Brooklands College
Weybridge

Block D
Plots: 56 - 74
Substructure Layout
Sheet 2

Scale	1:50 @ A1	Date	June 2023
Rev.	K	Drawn	JM
Dwg No.	SA00394-0261-A-FTD-SUB

SUBSTRUCTURE LAYOUT
SCALE 1:50

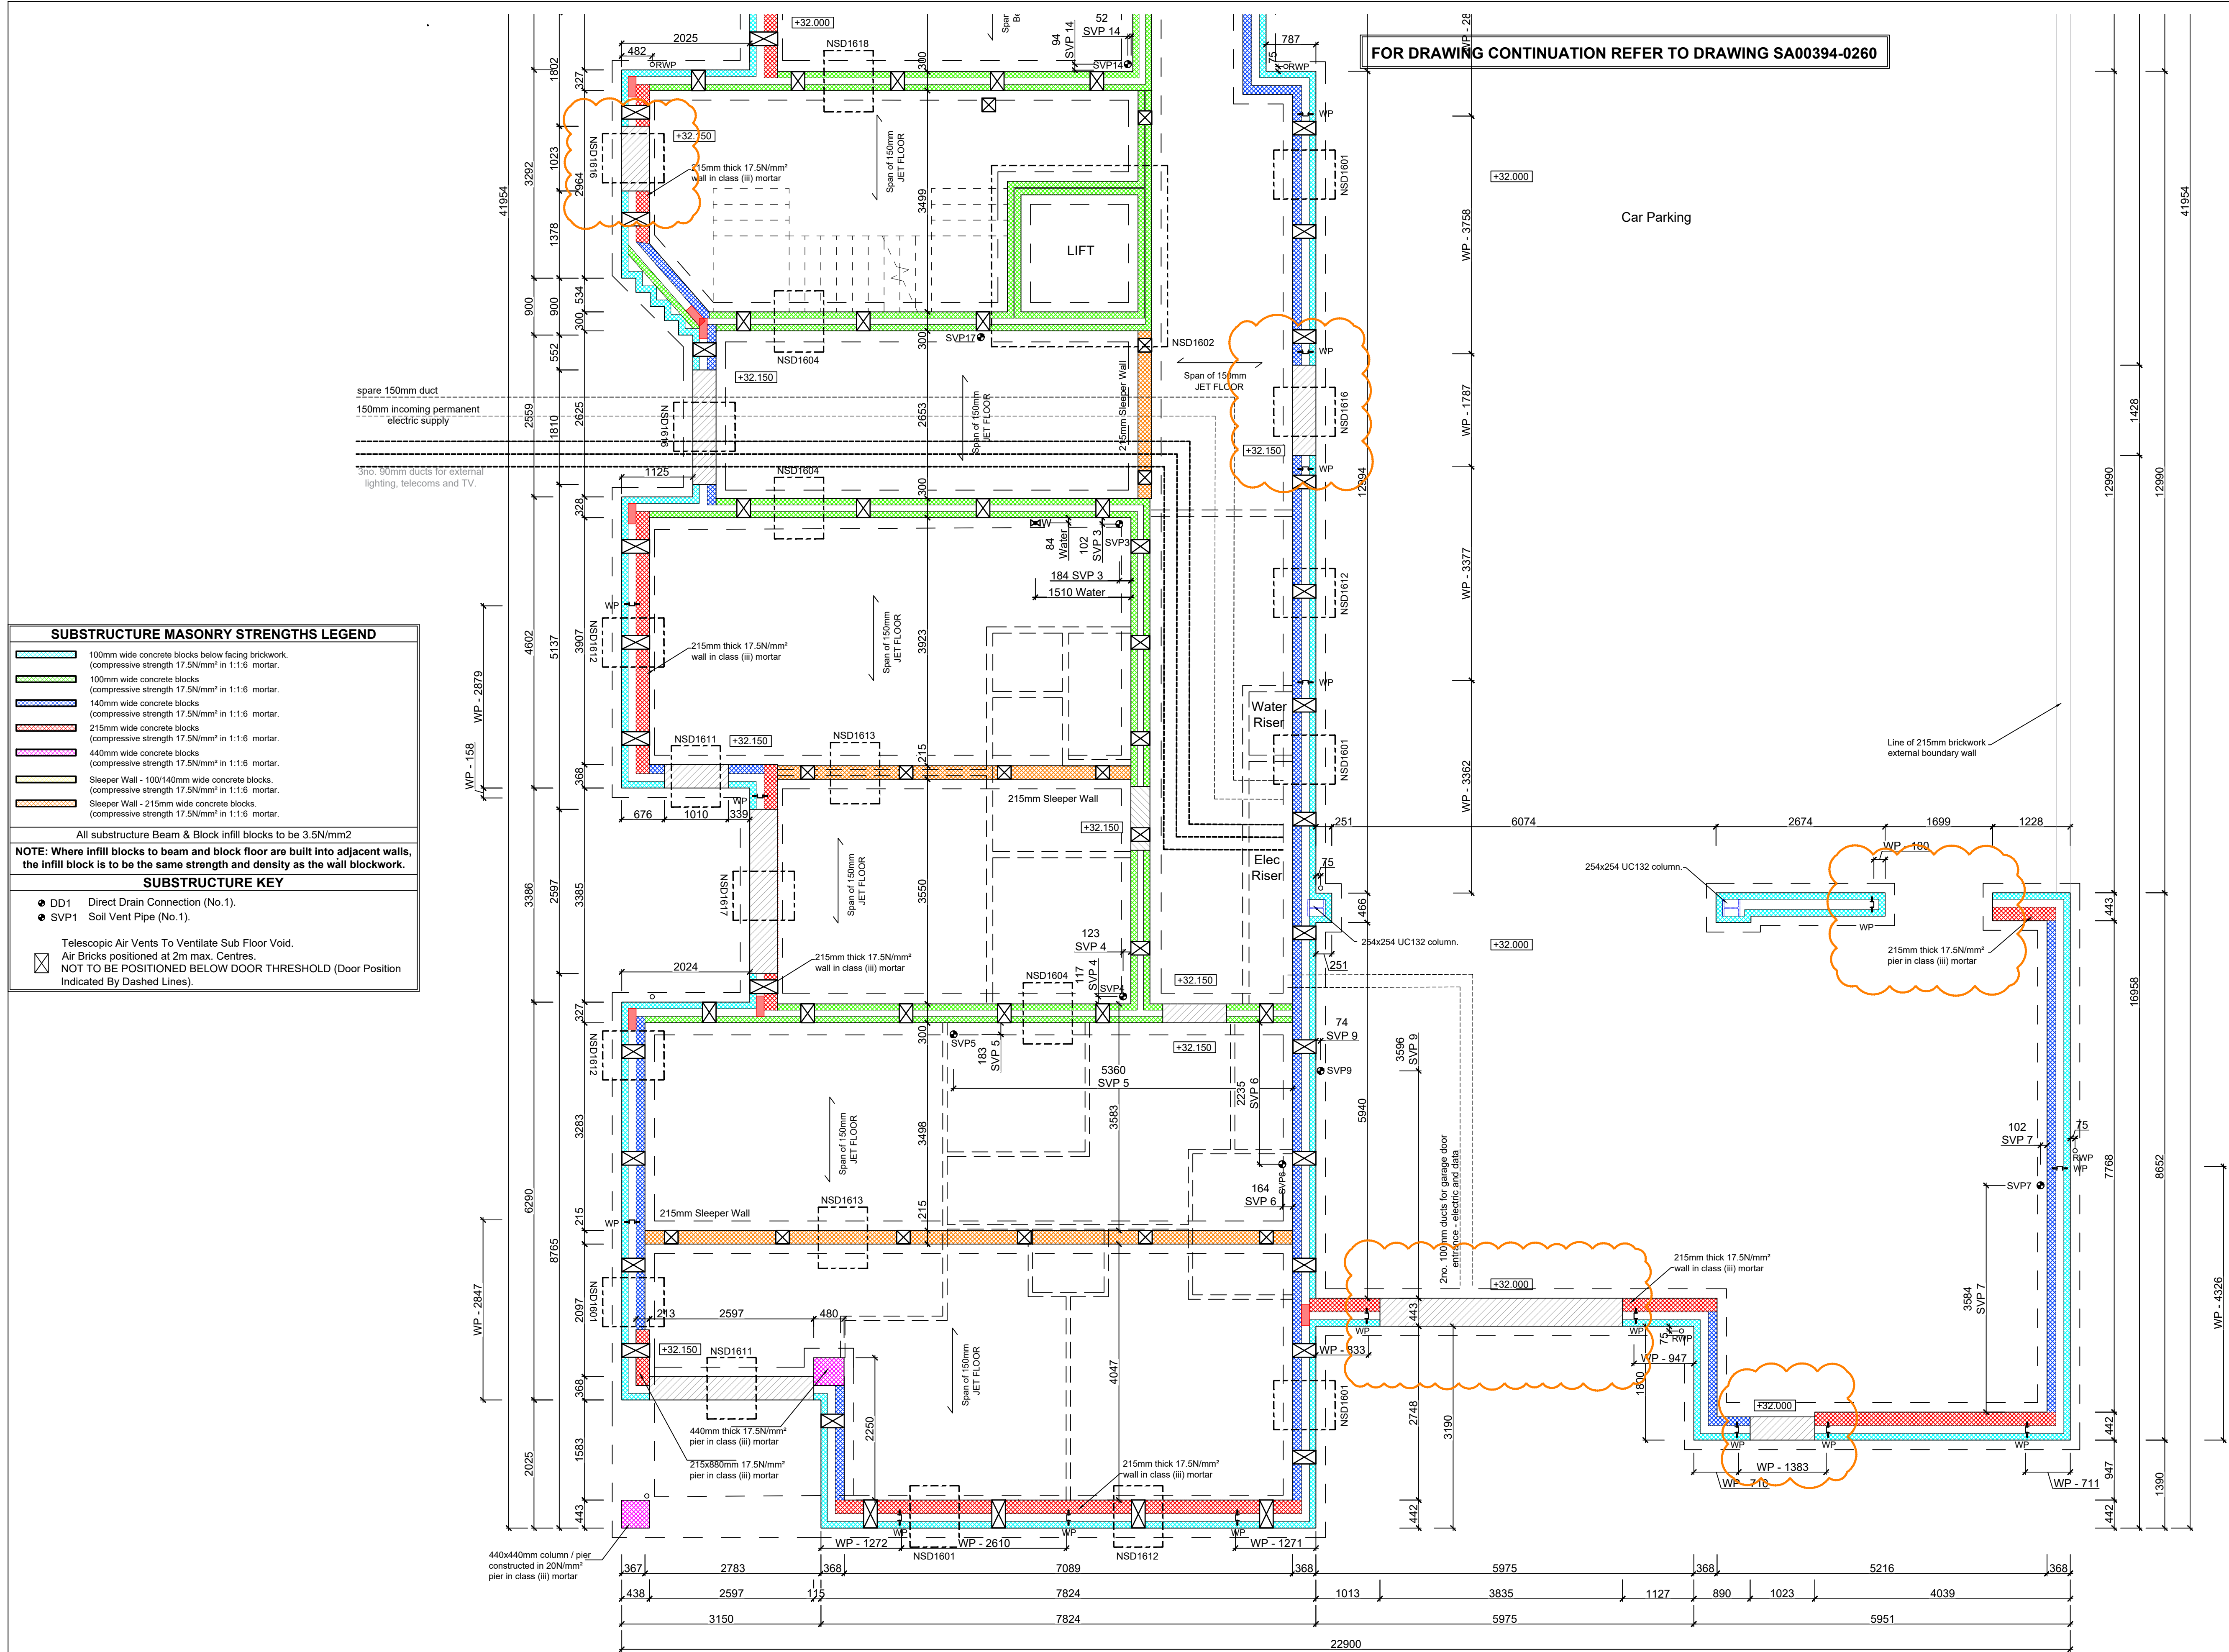
K	07.05.25	Openings updated as clouded to client comments. cant brickwork omitted & updated, wind posts added to S/E mark-ups and dimensions generally updated to brick dims.	MB	
J	09.04.25	Risers updated, gate feed added	ZJ	
I	04.04.25	B&B removed from covered car park area, setting out adjusted as circled, sub floor vents added as circled	ZJ	
H	07.03.25	Addition of block thickness legend & hatches. Substructure detail ref's added.	DF	
		Incoming services added in accordance with Utility site plan. Finished floor levels added.		
		Air brick review.		
G	22.01.25	Lift shaft structural opening adjusted (1850x1850). Internal flat layouts revised and soil pipes rationalised. Sleeper walls added inline with B&B design	DF/ZJ	
F	19.04.24	Drain socket added as clouded	MB	
E	22.03.24	Structural engineers information added.	GC	
D	16.02.24	Construction Issue. Structural coordination in abeyance	ZJ	
B	04.01.24	TENDER ISSUE	JM
